Approved Section: 4.55(1A) Application No: SSD-6339-Mod-3
Granted: 7 June 2021 Signed: *[Signature]*
Sheet no: 1 of 19

MODIFICATION APPLICATION

TITLE	
LEVEL 3 - PHASE A (REVISED PLAN)

PROJECT	
RPAC	
26 ALBION STREET WAVERLEY NSW 2024

LEVEL 5 - PHASE A (REVISED PLAN)

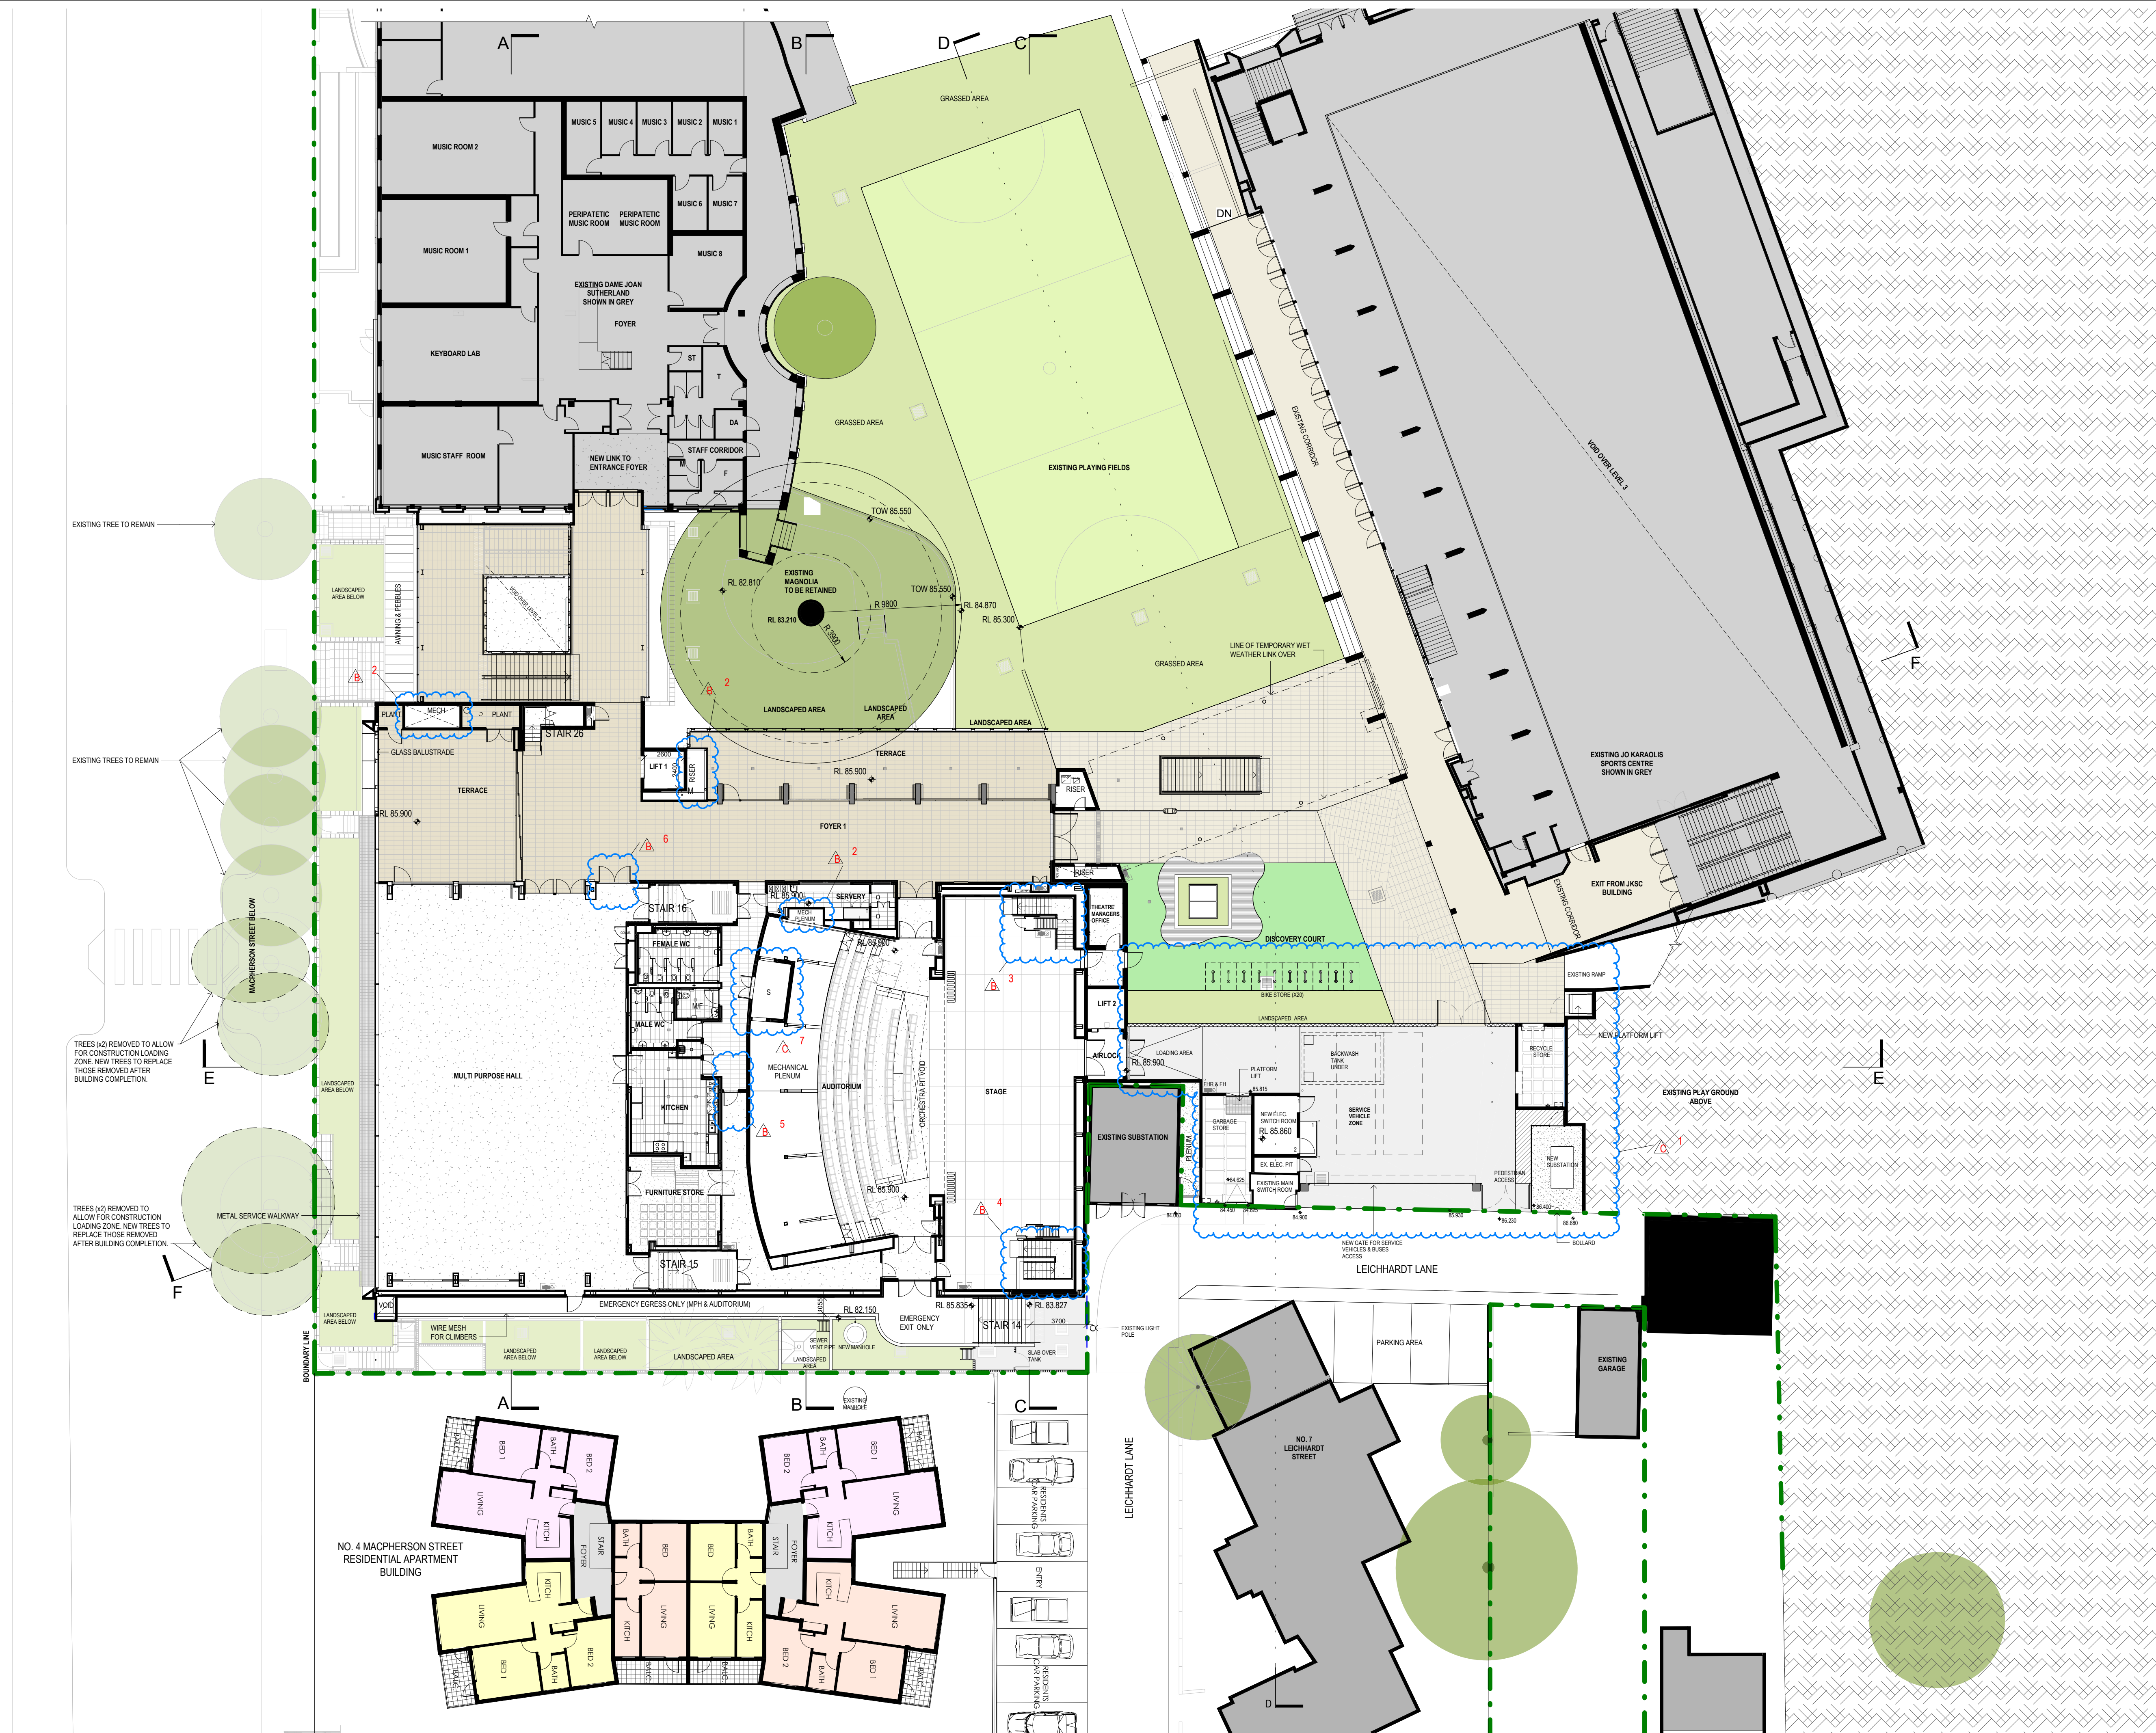
- LIST OF CHANGES LEVEL 5:
1. MEETING ROOM, CORRIDOR, AND STORE LAYOUT REVISED TO INCLUDE ACCESSIBLE BATHROOM TO SERVICE RPAC LEVEL 5 AND EXISTING DAME JOAN SUTHERLAND CENTRE FOR ACCESSIBILITY COMPLIANCE.
 2. REVISED LEVEL 5 LIFT CORRIDOR AND ADJACENT ROOMS LAYOUT FOR ACCESSIBILITY COMPLIANCE.
 3. SERVICES RISER AND CEILING CAVITY REVISED FOR SERVICES RETICULATION
 4. NEW MECHANICAL PLENUM INCLUDED FOR SERVICES RETICULATION
 5. REVISED VERTICAL ACCESS ARRANGEMENT TO THE STAGE CATWALKS FOR COMPLIANCE AND IMPROVED FUNCTIONALITY.
 6. NEW SUBSTATION LOCATION AND REVISED SERVICE VEHICLE ZONE IN LEVEL 4 (LEVEL BELOW)
